PPM Reactive Power modifications to EREC G99/NI

Distribution Code Consultation

Date published: 16 June 2023

Figure 13.6 Reactive Power capability requirements (**Synchronous Power Generating Modules operating at Registered Capacity**)

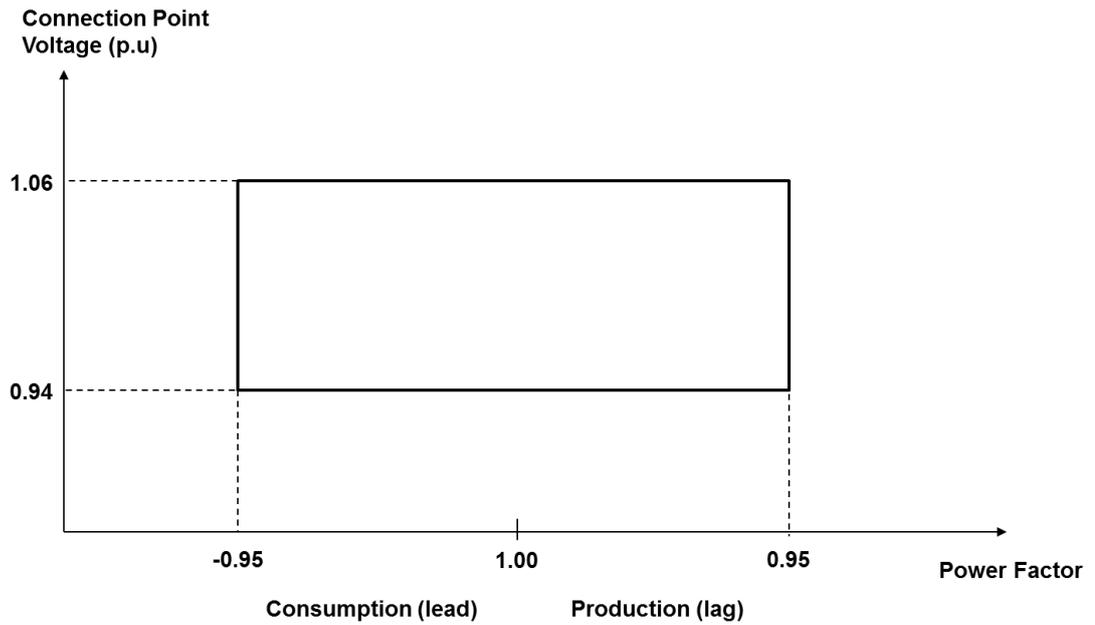
Clarification that Figure 13.6 refers to Synchronous Power Generating Modules by amending the caption to “Reactive Power capability requirements (Synchronous Power Generating Modules operating at Registered Capacity)”.

Paragraph 13.5.3 specifies the voltage limits above and below which a Synchronous Power Generating Module shall maintain the Reactive Power output and Power Factor as far as possible recognising the constraints expressed by the Generator Performance Chart. It is proposed that the voltage limits be adjusted from above 1.05 pu or below 0.95 pu to above 1.06 pu or below 0.94 pu. This is consistent with Figure 13.6 and Northern Ireland existing requirements.

13.5.1 All **Synchronous Power Generating Modules** shall be capable of satisfying the **Reactive Power** capability requirements at the **Connection Point** as defined in Figure 13.6 when operating at **Registered Capacity**. In some cases, for example, on large industrial sites etc where the **Synchronous Power Generating Module** is embedded in the **Generator's Installation**, the **DNO** may specify requirements that fit within the rectangular boundary defined in Figure 13.6, ie an envelope agreed between the **DNO** and the **Generator** within the rectangle of Figure 13.6. In such cases the **DNO** and **Generator** might agree a different control point, such as the **Power Generating Module's** terminals. The performance requirements of the control system including **Slope** (where applicable) shall be agreed between the **DNO** and the **Generator**. For the avoidance of doubt, where the **Generator's Installation** involves **Power Generating Modules** and demand the entire **Generator's Installation** shall be considered to be a **Power Generating Facility** and shall be capable of delivering **Reactive Power** performance at the **Connection Point**. However, where complex **Generator's Installations** involve **Power Generating Modules** and demand, the **Generator** may submit calculations to support compliance.

13.5.3 At voltages above 1.06 pu, or below 0.94 pu a **Synchronous Power Generating Module** shall maintain the **Reactive Power** output and **Power Factor** as far as possible recognizing that outside of the envelope of Figure 13.6 it will be necessary for the **Reactive Power** and/or **Power Factor** to be constrained by the capability as expressed on the **Generator Performance Chart**.

Figure 13.7 Reactive Power capability requirements (**Synchronous Power Generating Modules operating below Registered Capacity**)

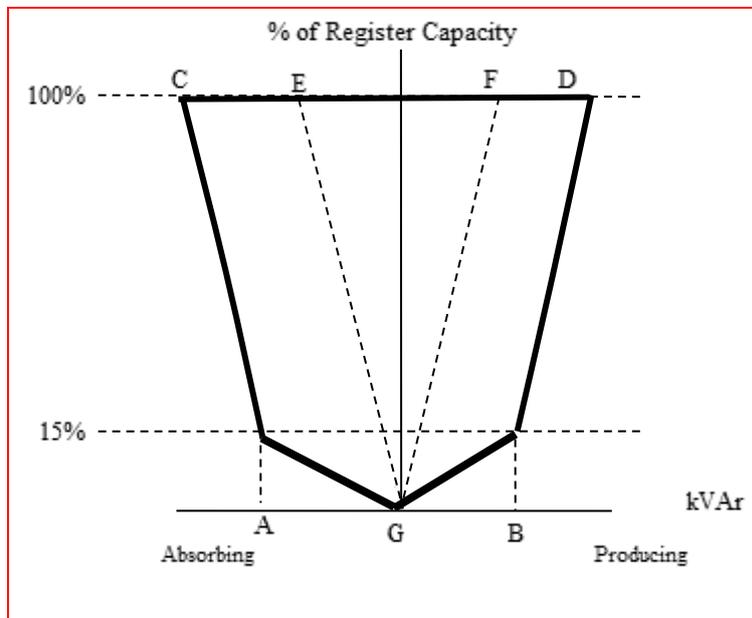
Clarification that Figure 13.7 refers to Synchronous Power Generating Modules by amending the caption to “Reactive Power capability requirements (Synchronous Power Generating Modules operating below Registered Capacity)”.

13.5.2 At **Active Power** output levels other than **Registered Capacity** all **synchronous Generating Units** shall be capable of satisfying the **Reactive Power** capability requirements at the **Connection Point** as defined in Figure 13.7 when operating below **Registered Capacity**, taking the auxiliary supplies and the **Active Power** and **Reactive Power** losses of the **Power Generating Module** transformer or **Station Transformer** into account. These **Reactive Power** limits will be reduced pro rata to the amount of plant in service.

13.8.3.1 Whilst the **Synchronous Power Generating Module** is operating in **Power Factor** control mode its reactive capability is described by the envelope EFG within the **Reactive Power** capability chart given in Figure 13.7.

13.8.3.2 Whilst the **Synchronous Power Generating Module** is operating in voltage control mode, the minimum reactive capability is described by the envelope ACDBG within the **Reactive Power** capability chart given in Figure 13.7.

13.8.3.3 Whilst the **Synchronous Power Generating Module** is operating in VAr Control Mode the **Power Generating Modules** shall be capable of importing or exporting VARs within the envelope described by ACDBG within the **Reactive Power** capability chart given in Figure 13.7.

Figure 13.8 Reactive Power capability requirements (Power Park Modules operating at Registered Capacity)

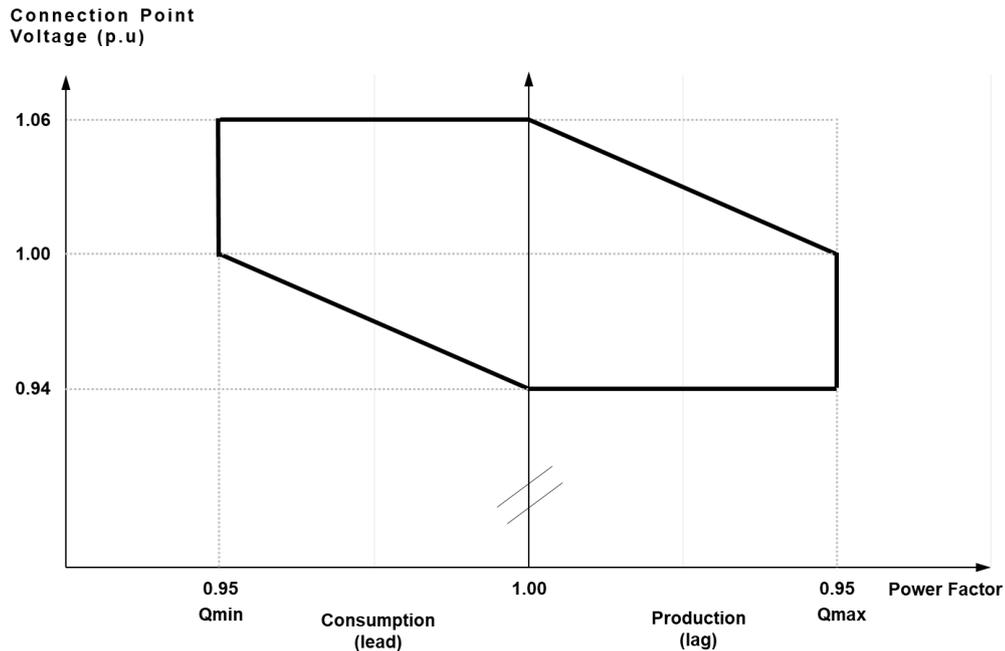
The approach taken in Engineering Recommendation G99 GB, for Power Park Modules connecting below 33 kV where the specified power factor/ voltage capability is not rectangular but shaped to allow the reactive power contribution at the connection point to reduce as the voltage rises and the reactive power consumption to reduce as the voltage falls has been adopted. This should reduce the cost of the connection, especially where there is a large distance between the Power Park Module and the connection point.

Proposed addition of paragraph 13.5.4, “All Power Park Modules shall be capable of satisfying the Reactive Power capability requirements at the Connection Point as defined in Figure 13.8 when operating at Registered Capacity.” In addition, it is proposed to add Figure 13.8 which depicts the Reactive Power capability requirements for Power Park Modules operating at Registered Capacity. This is a non-rectangular requirement.

Proposed addition of paragraph 13.5.5, “At voltages above 1.06 pu, or below 0.94 pu a Power Park Module shall maintain the Reactive Power output and Power Factor as far as possible recognizing that outside of the envelope of Figure 13.8 it will be necessary for the Reactive Power and/or Power Factor to be constrained by the capability as expressed on the Generator Performance Chart.”

13.5.4 All **Power Park Modules** shall be capable of satisfying the **Reactive Power** capability requirements at the **Connection Point** as defined in Figure 13.8 when operating at **Registered Capacity**.

13.5.5 At voltages above 1.06 pu, or below 0.94 pu a **Power Park Module** shall maintain the **Reactive Power** output and **Power Factor** as far as possible recognizing that outside of the envelope of Figure 13.8 it will be necessary for the **Reactive Power** and/or **Power Factor** to be constrained by the capability as expressed on the **Generator Performance Chart**.

13.5.6 When operating below **Registered Capacity**, all **Power Park Modules**, shall be capable of satisfying the **Reactive Power** capability requirements at the **Connection Point** as defined in Figure 2 and Figure 3 of the **PPM Setting Schedule** when the **Connection Point** voltage is 1.0 pu. When the **Connection Point** voltage is not 1.0 pu, the **Reactive Power** capability requirements defined in Figure 2 and Figure 3 of the **PPM Setting Schedule** shall be limited in accordance with those indicated by Figure 13.8. These **Reactive Power** limits will be reduced pro rata to the amount of plant in service.
